California Stormwater Quality Association®

Subject: Comment Letter – Industrial General Permit issued July 19, 2013

Attachment 1. Detailed Comment Table

Attachment 3. Cumulative Hourly Rainfall Intensity Curves from the CASQA New Development Handbook

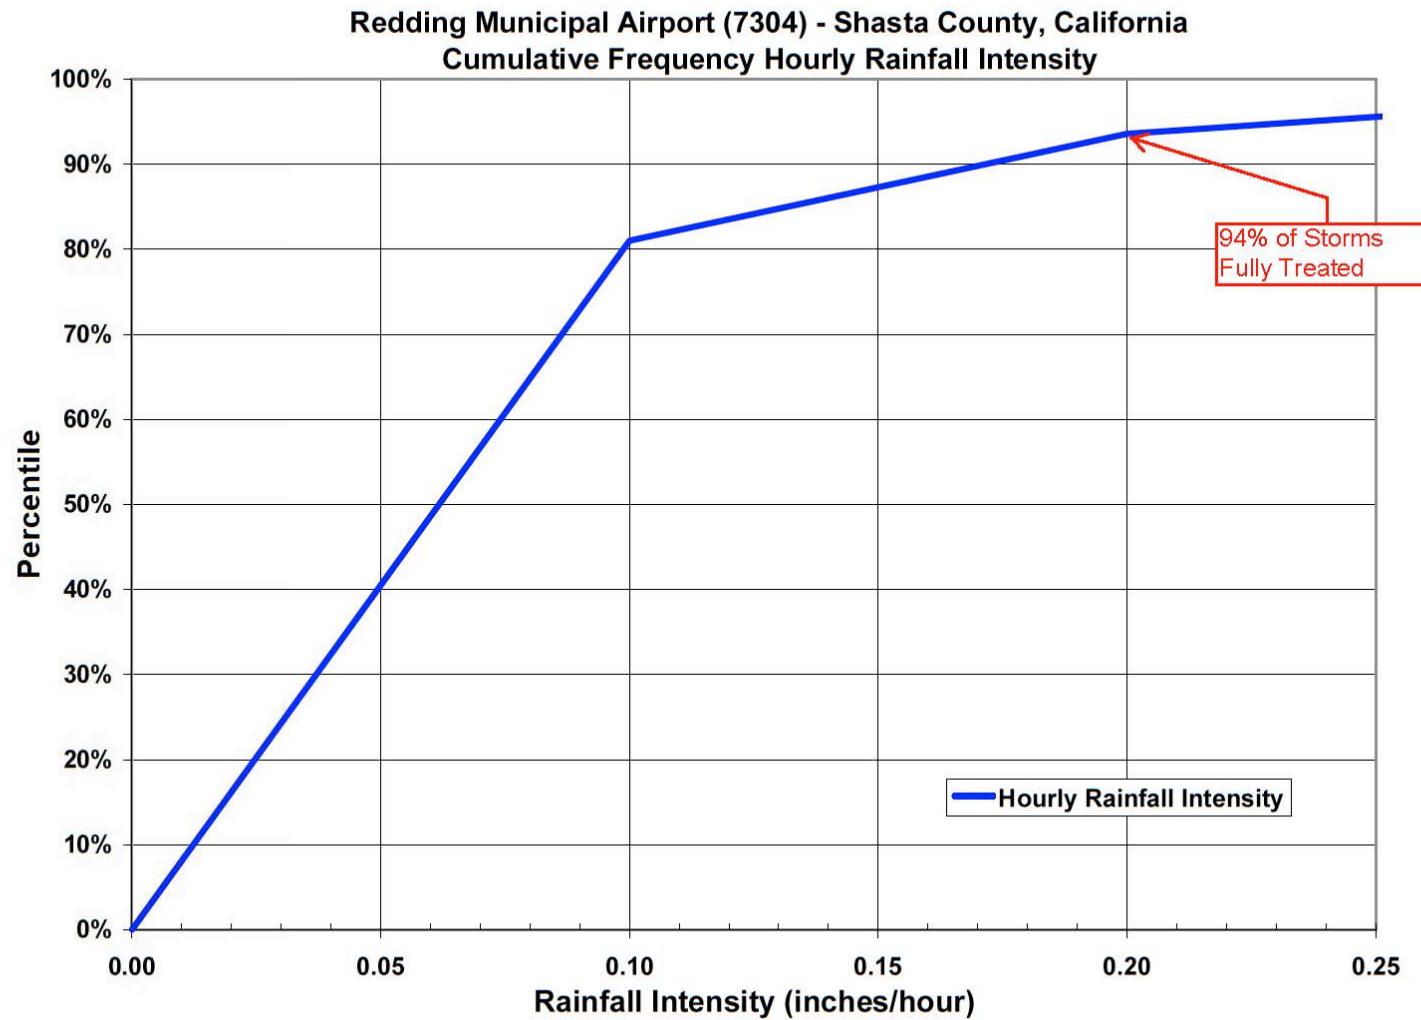
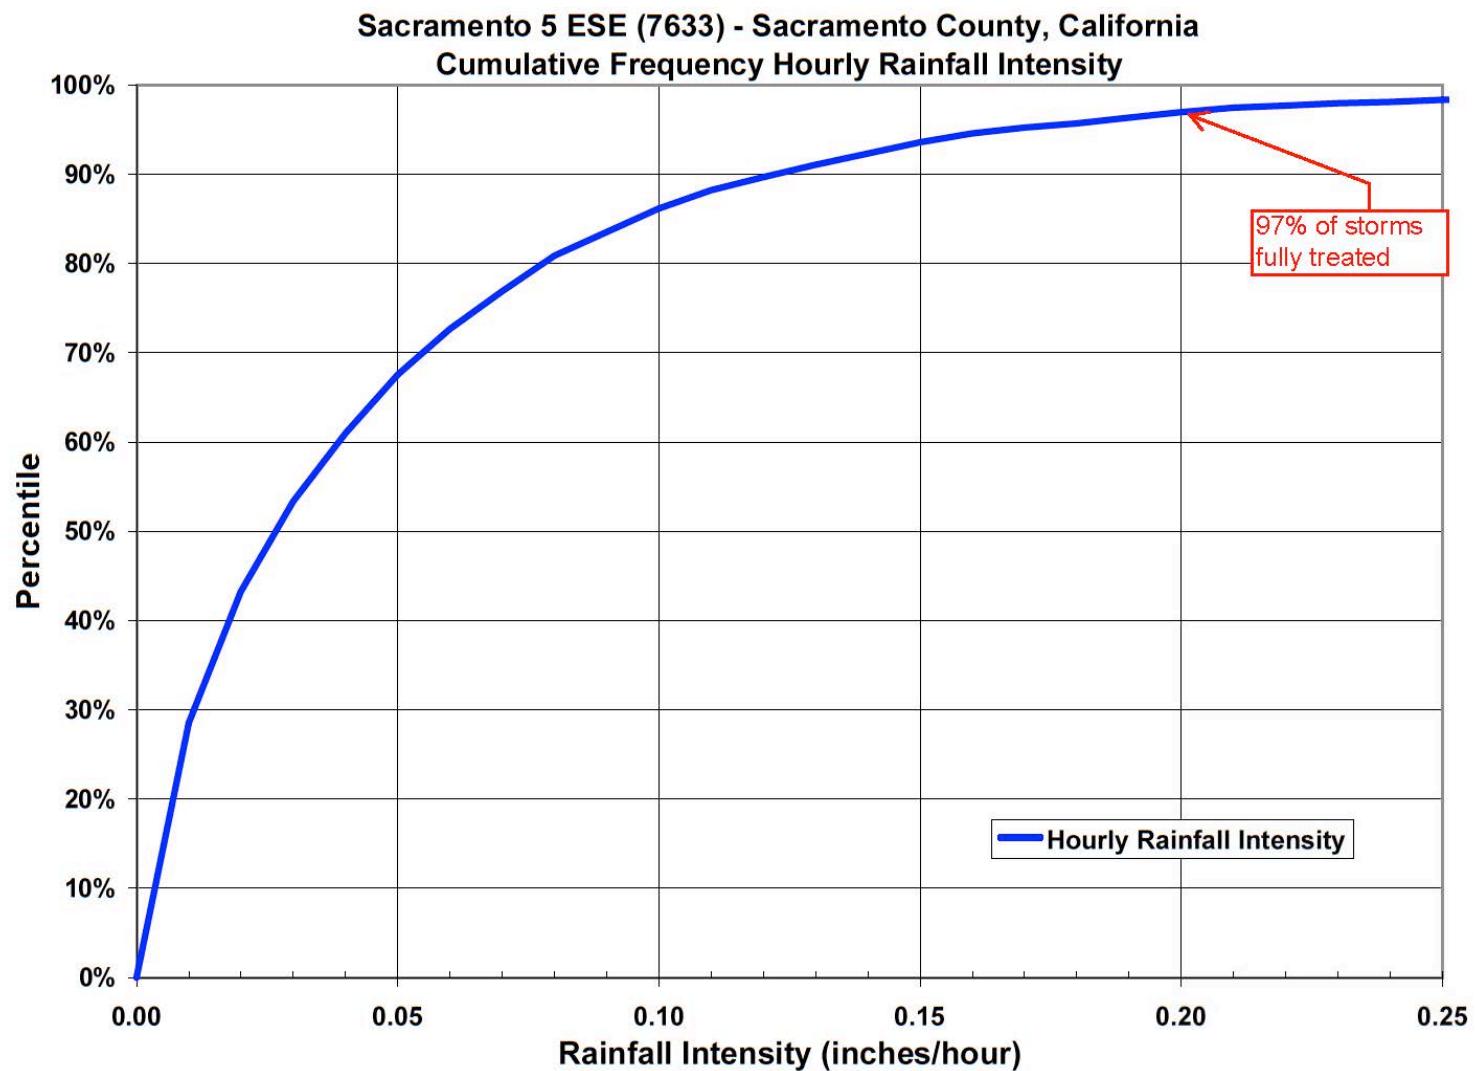
54	48. 0.2 inches per hour intensity for flow-based Treatment Control BMP design	Order H.6.b.i and H.6.b.ii pg 34-35	<p>Specifically related to the selection of design storm standards for design of flow-based treatment control BMPs, CASQA supports the inclusion of both approaches for calculating the volume of runoff to be treated.</p> <p>Section X.H.6.b.i requires that the discharger calculate the flow to be treated using the maximum flow rate of runoff produced from a rainfall intensity of 0.2 inches per hour for each hour of the storm event (Uniform Intensity Approach). This is a simple, practical approach that allows dischargers to plan</p>

Item No.	Element/Issue/Concern	Location in Draft General Permit	Comment
			<p>treatment control BMPs. It is especially useful for dischargers located in areas where adequate historical rainfall data is unavailable. This design storm approach is consistent with many SUSMP, LID, and site development standards across the state and is an approved methodology in the Phase II Permit.</p> <p>Section X.H.6.b.ii requires the discharger to design the treatment control BMP to address the flow rate of runoff produced by the 85th percentile hourly rainfall intensity, as determined from local historical rainfall records, multiplied by a factor of two (California Stormwater BMP Handbook Approach). CASQA recognizes that rainfall intensities vary across the state and depending on discharger location, application of this methodology may result in calculated runoff flow rates to be treated that are greater than or less than the flow calculated by the Uniform Intensity Approach.</p> <p>Application of the Uniform Intensity Approach provides full treatment for a high percentage of storms – in the case where the rainfall intensity and resultant runoff exceeds the treatment capacity, partial treatment is still provided. The curves presented in Appendix D of the <i>CASQA Stormwater Best Management Practice Handbook for New Development and Redevelopment</i> (CASQA Handbook, January 2003) demonstrate that application of the Uniform Intensity Approach for design of treatment control BMPs provides treatment for more than 90 percent of the storms included in CASQA's statewide evaluation. For example, for the Redding Municipal Airport, 94 percent of the storms were less than or equal to 0.2 inches per hour intensity and would be fully captured by a treatment system designed to this flow rate standard. Similarly, for Sacramento, 97 percent of the storms would be captured and fully treated. For Los Angeles WSO Airport, 93 percent of the storms would be captured and fully treated. Cumulative Hourly Rainfall Intensity Curves from the CASQA Handbook are attached for reference (Attachment 3).</p>
